CONNECTICUT YANKEE ATOMIC POWER COMPANY

HADDAM NECK PLANT

Haddam Neck Plant
Request for Modification of Exemption for the
Shipment of Reactor Pressure Vessel

Revised Addendum to Transport System Description Report

ADDENDUM FIGURE 1

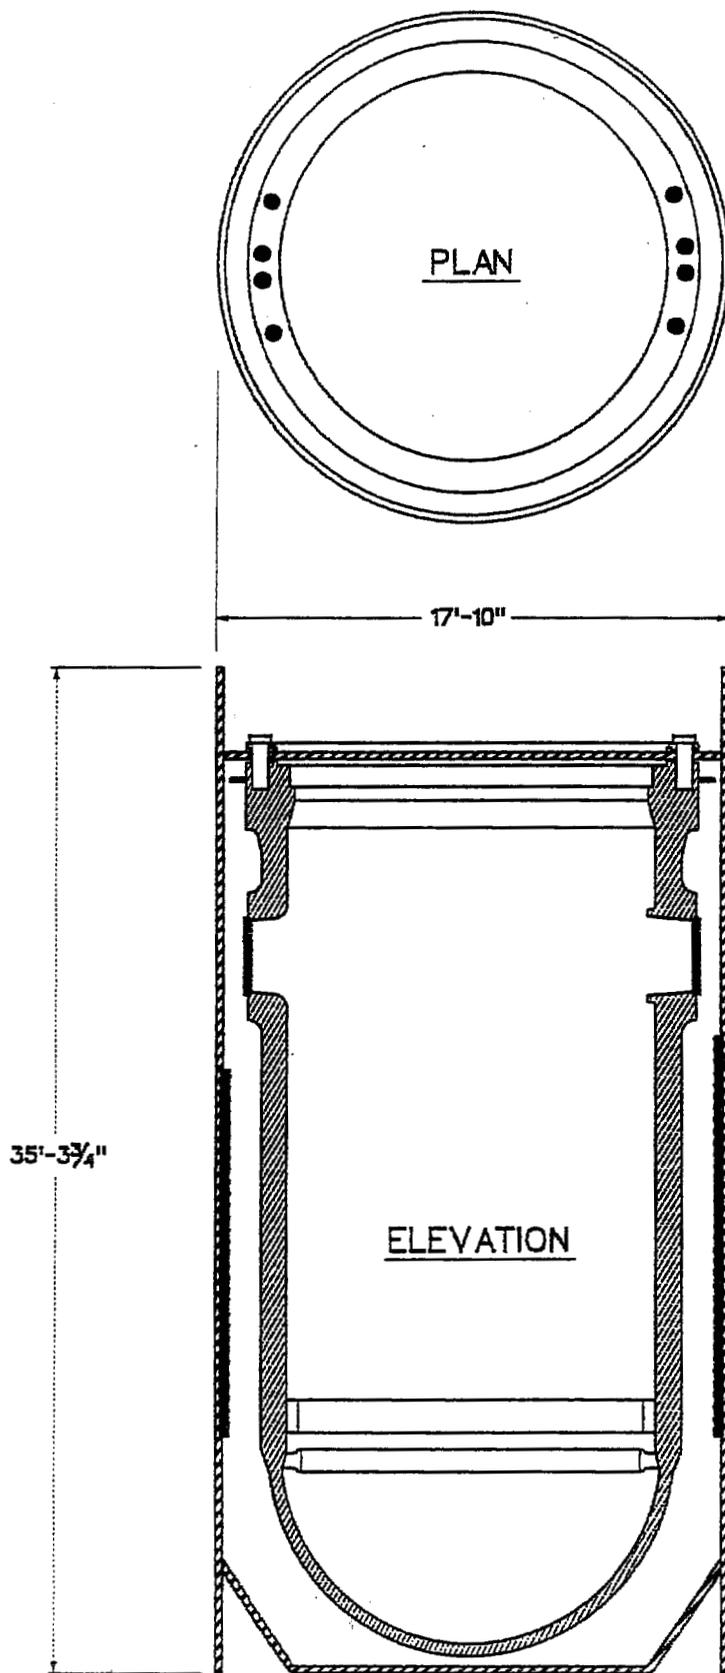
TSDR Section	Comments Concerning Reconfigured RVTS
Figure 1-4: "HNP Package Shipping Configuration"	Addendum Figure 1 displays the reconfigured Package Shipping Configuration.

ADDENDUM FIGURE 2

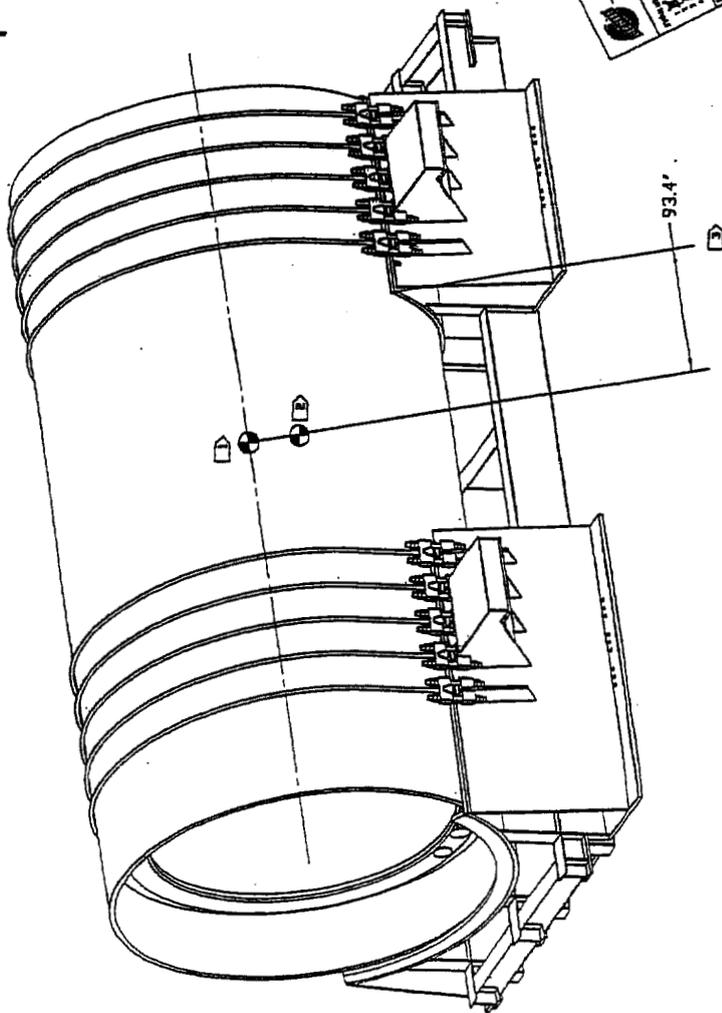
2.5: Tie-down System	With the identified absence of closure head, vessel nozzles, and vessel insulation, the center of gravity of the loaded canister of the RVTS is different from the previously planned configuration. In order to more evenly distribute the footprint loads of the cradle, the canister is reversed in the RVTS cradle. An evaluation of the relevance of previous analysis to the reconfigured RVTS is provided by Supplemental Reference #1 Bechtel Engineering Judgment Document 24265-200-30V-C12K-00012-000.

2.5.1: Tie-down System Design Criteria and Analysis Results	Supplemental Reference #1 concludes that the previously referenced analyses for the tie-down system and the cradle are valid for the reconfigured RVTS.
Figure 2-1: "Tie-down System"	Addendum Figure 2 displays the reconfigured tie-down system configuration.

ADDENDUM FIGURE 3

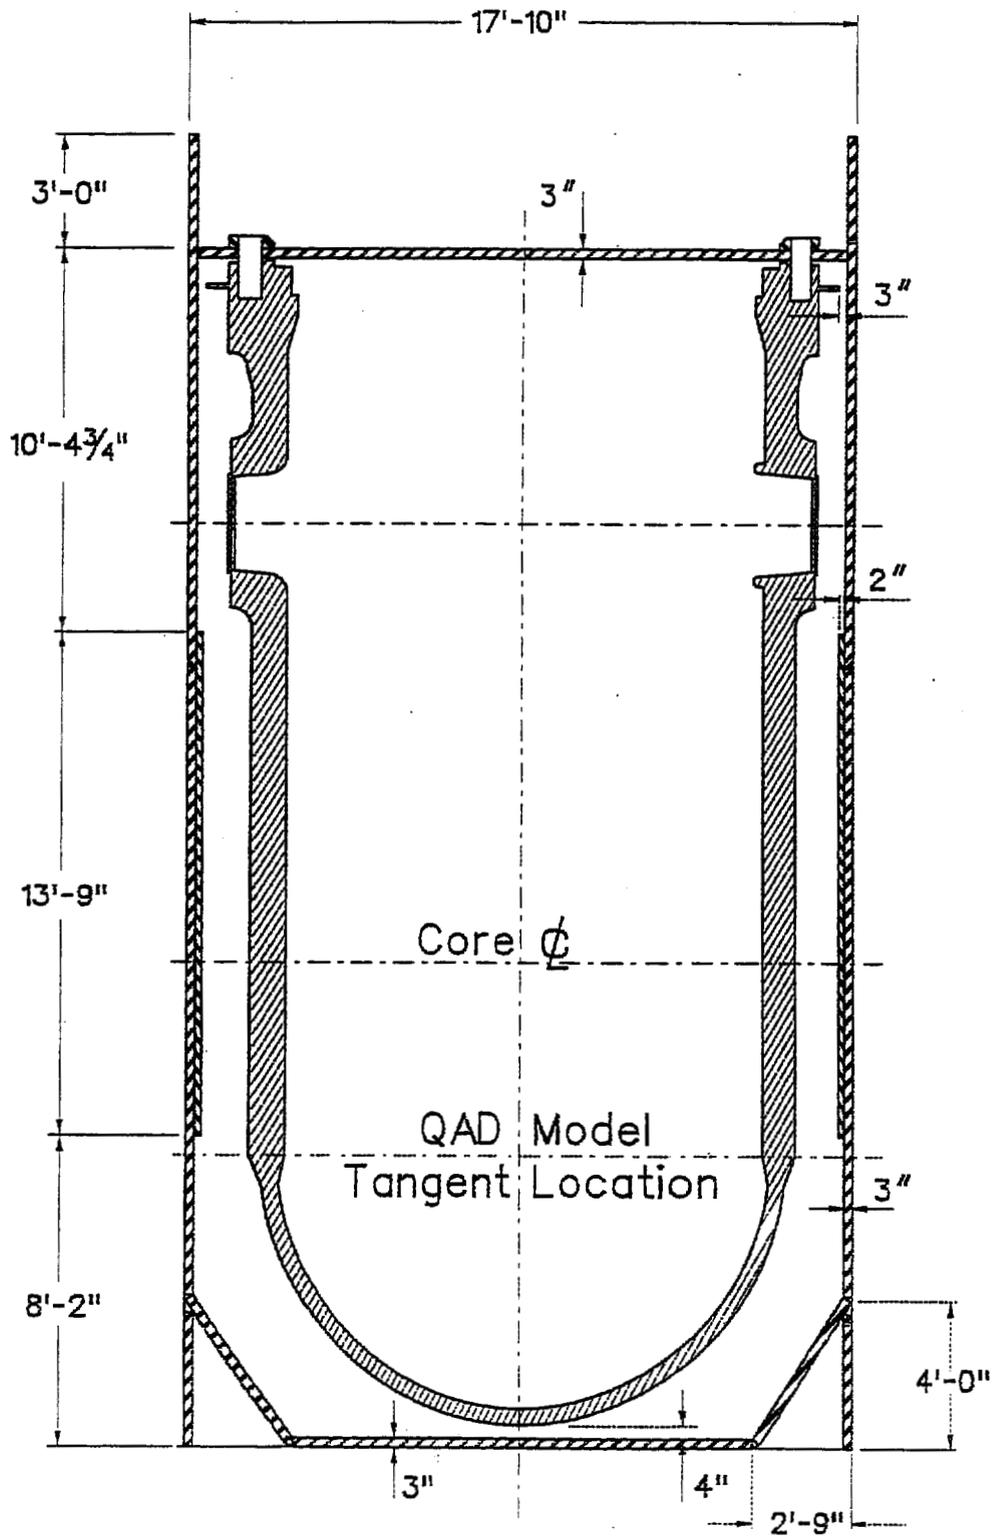
TSDR Section	Comments Concerning Reconfigured RVTS
<p>4.0: Shielding Evaluation – Introduction Paragraph</p>	<p>Figure 4-1 of the TSDR is a Y-Z cross section of the modeled RPV and internals in their anticipated shipping configuration.</p> <p>As summarized in Supplemental Reference #2, the analytical results from the application of this shielding model are applicable to all geometric vectors from the reconfigured RVP package, including vectors that intersect the top of the canister, with its reconfigured penetration closures.</p> <p>The features of the reconfigured RVP package are: (a) no change to the geometry of the source material, (b) no changes to the location of the ALARA shield, (c) no change to the thickness or material of the top of the canister, and (d) penetration closures for the top of the canister that have dimensions which are consistent with the shielding provided by the 3” thickness of the canister top plate.</p> <p>The reconfigured RVTS does not include the reactor vessel head as an attachment to the exterior of the top of the canister. Additionally, the center plug of the ALARA shield will not be included in the RVTS. The ALARA shield is 94% intact, with the remaining portion having a thickness of three inches (Supplemental Reference #5).</p>
